ADDENDUM NO. 1
TO THE
DRAWINGS AND SPECIFICATIONS
FOR THE
17TH Street Reconstruction

Issued From: The City of Bloomington
Planning and Transportation Department
Post Office Box 100
401 North Morton Street, Suite #130
Bloomington, Indiana 47402

Issue Date: January 24th, 2019

LIGHT FOUNDATION

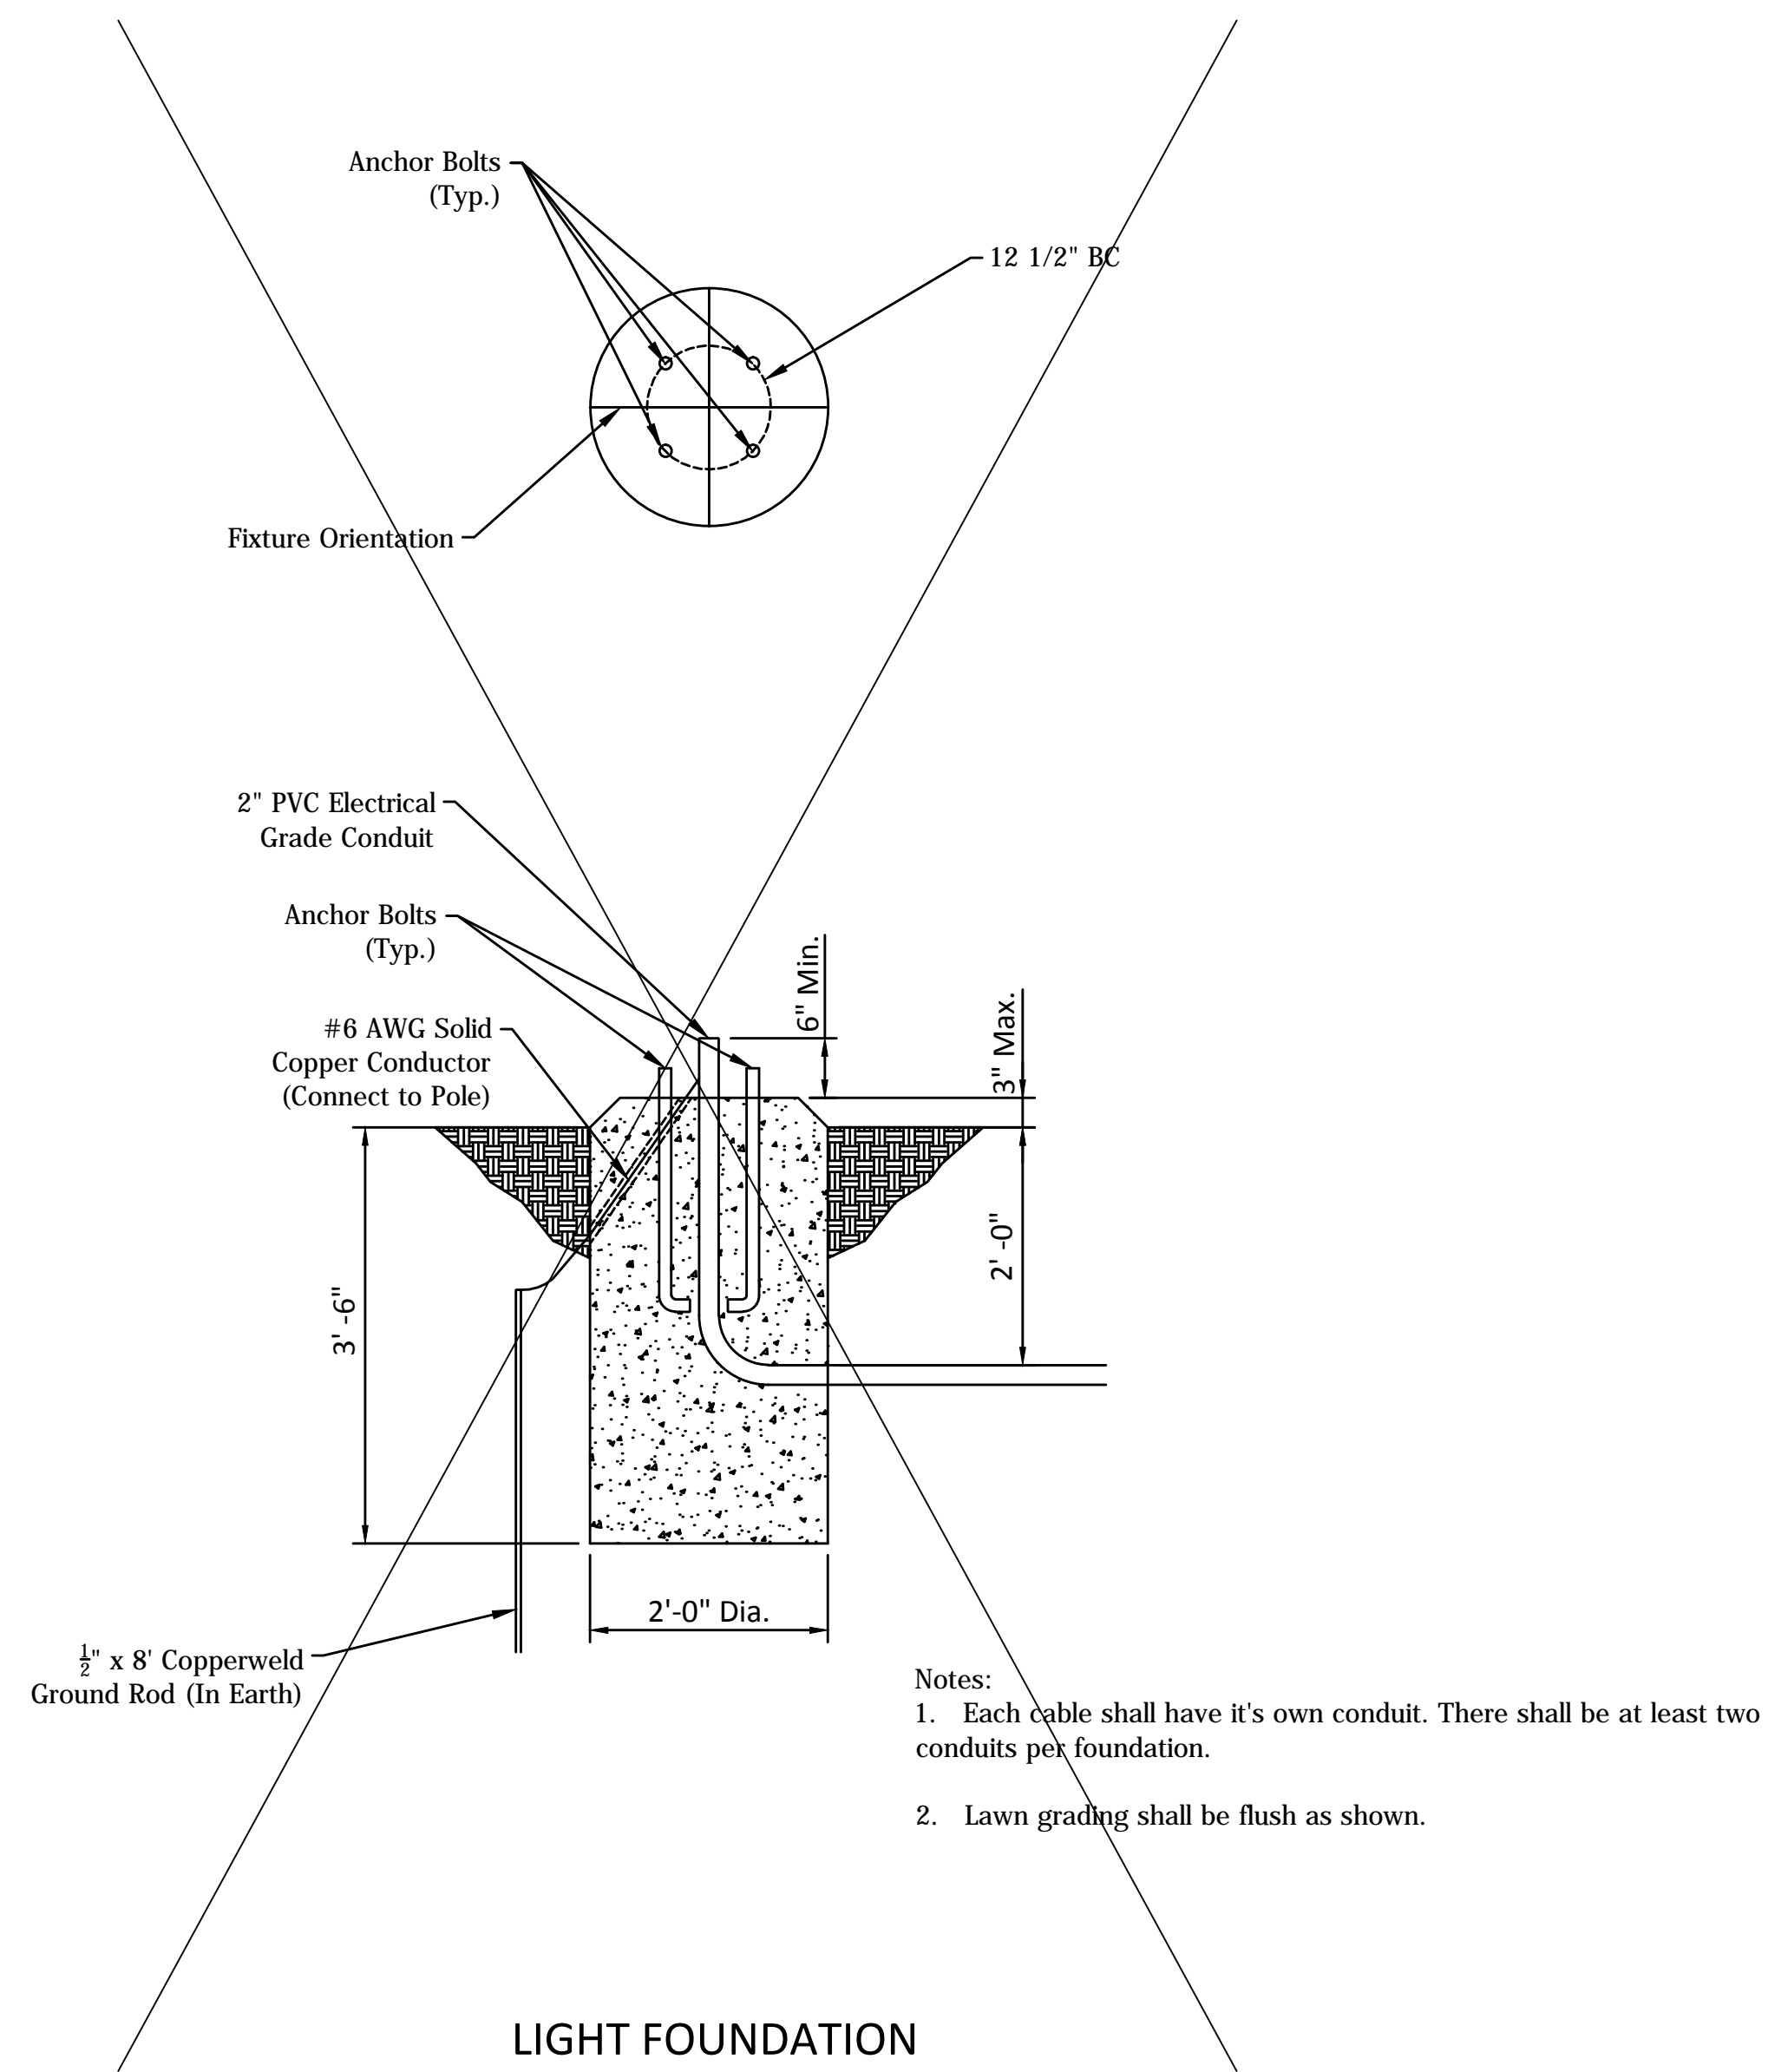
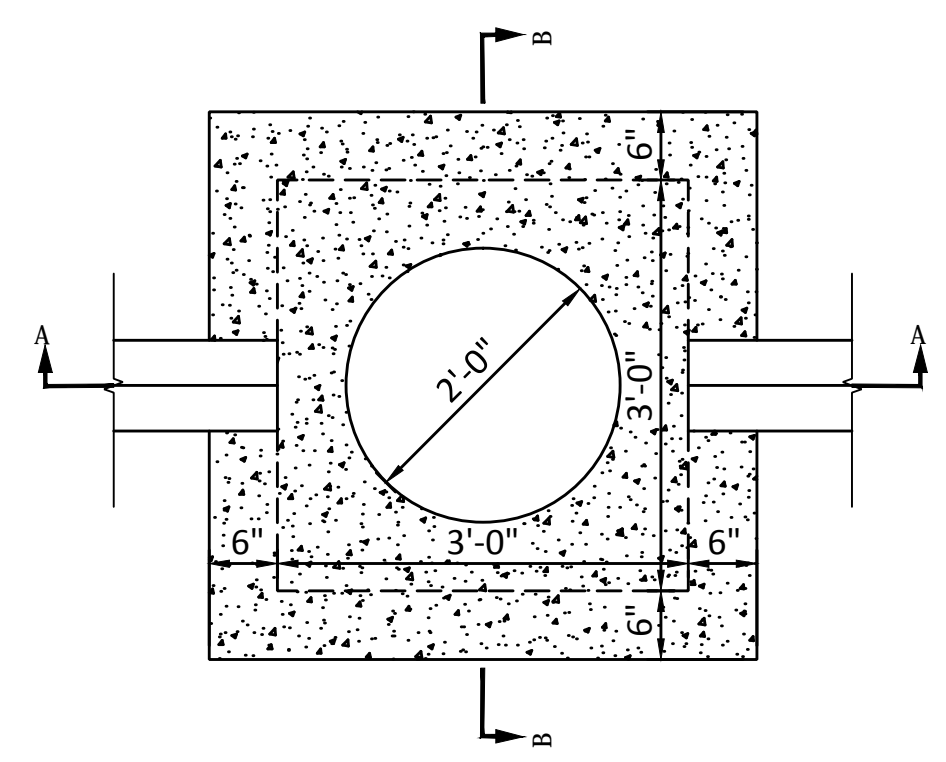
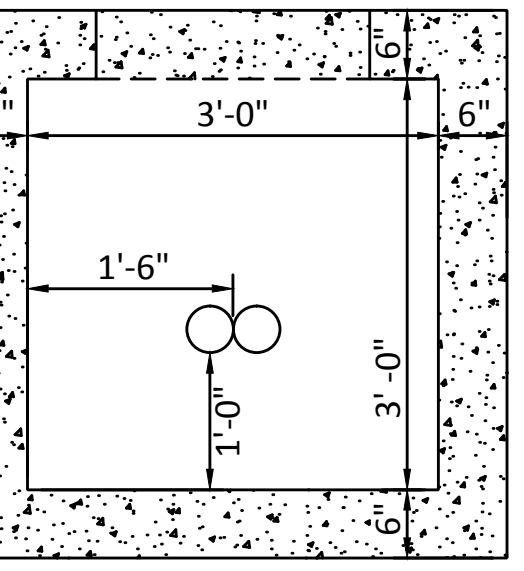
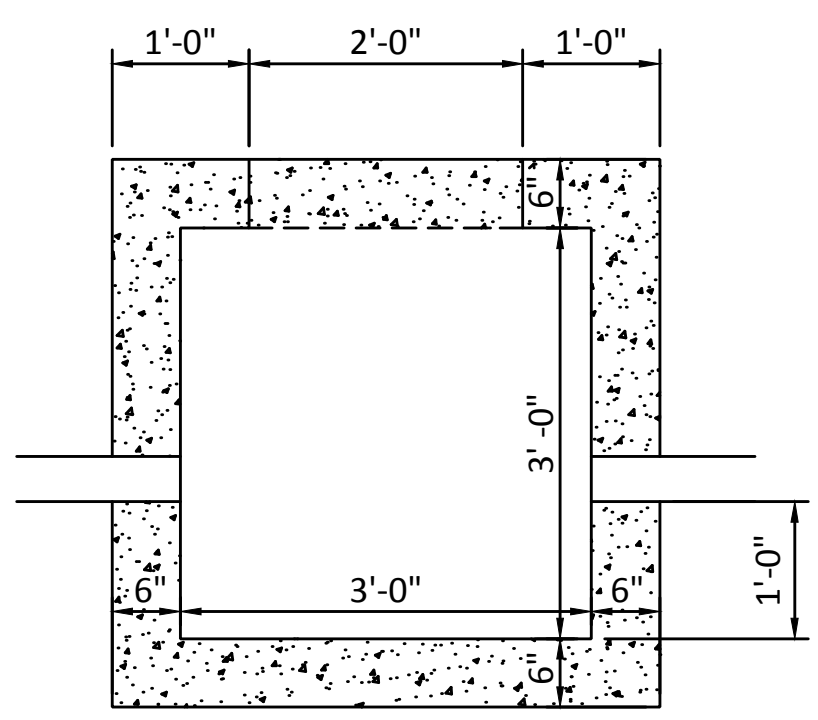
Duke Energy's design team has now recommended that direct buried poles be utilized on this project. Duke Energy will be furnishing and installing the direct buried pole. Therefore, Light Pole Foundations have been deleted on Sheets 46-49 as well as the detail on sheets 54. Revised Plan sheets 46-49, and 54, and a revised "Proposal Schedule of Items" have been added per this addendum.

Duke Energy will be providing and installing direct buried light poles.

CITY OF BLOOMINGTON
TREE REMOVAL PLAN
STA 26+00 TO STA 32+00

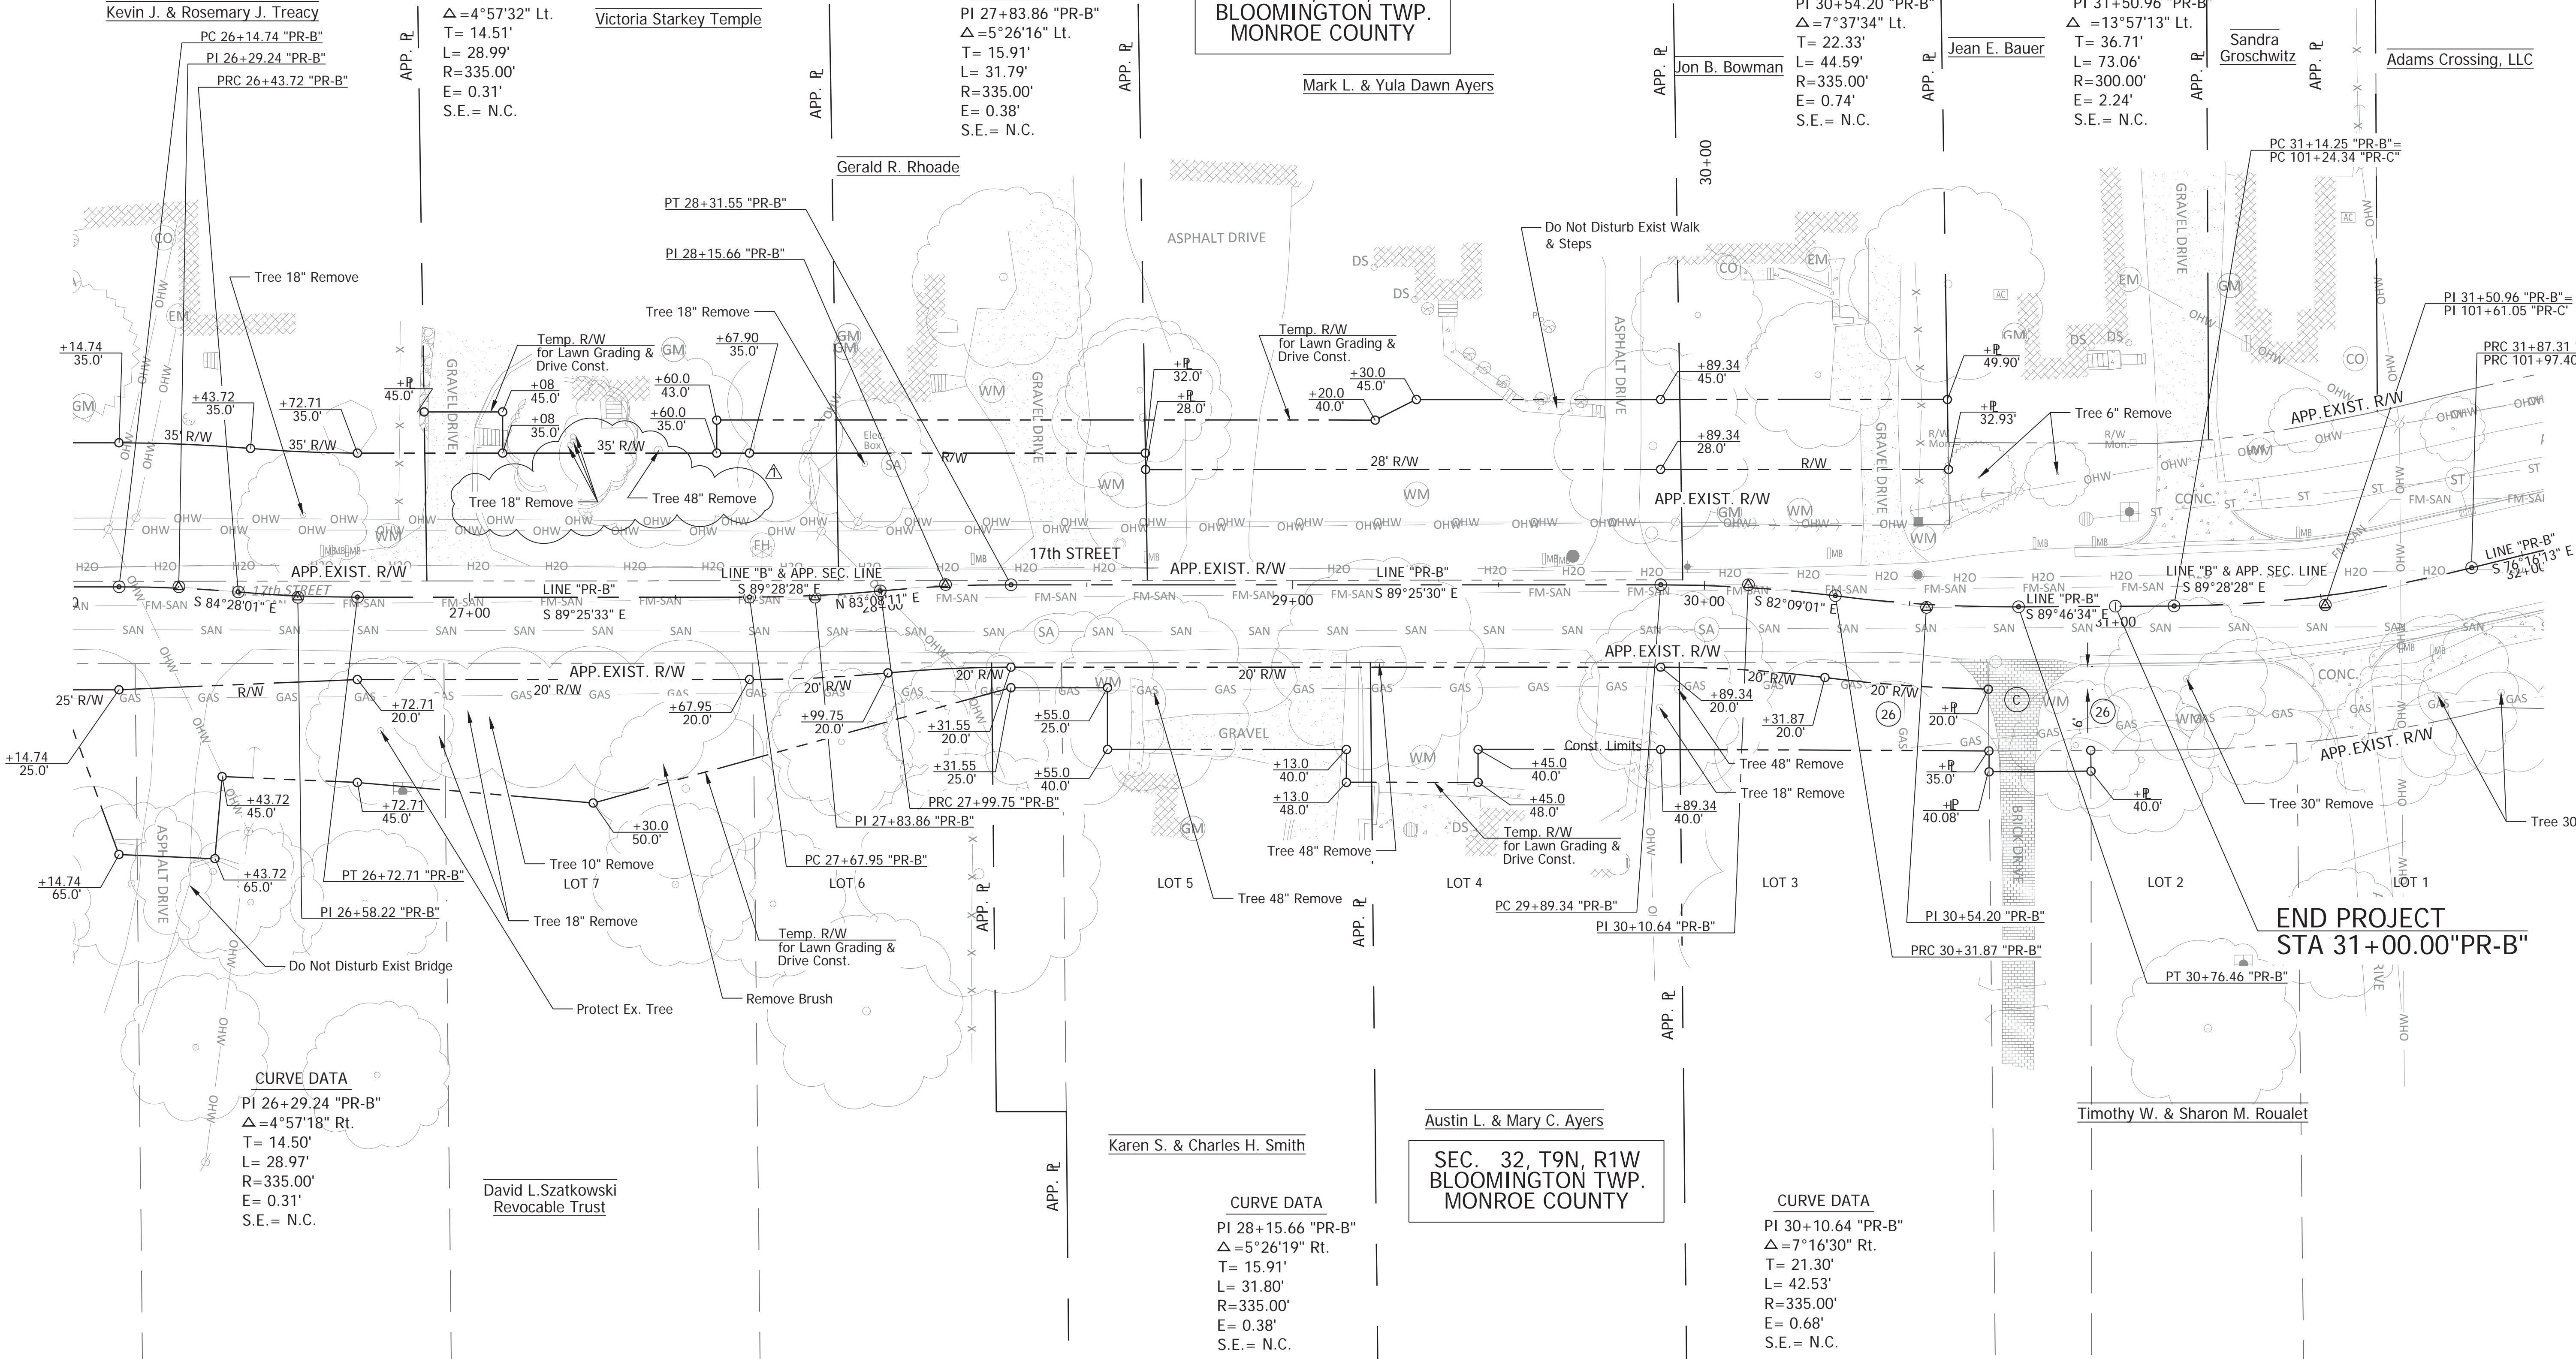
The Tree Removal Details, sheets 68 & 69, have been revised. Revised plan sheets and a revised "Proposal Schedule of Items" have been added per this addendum.
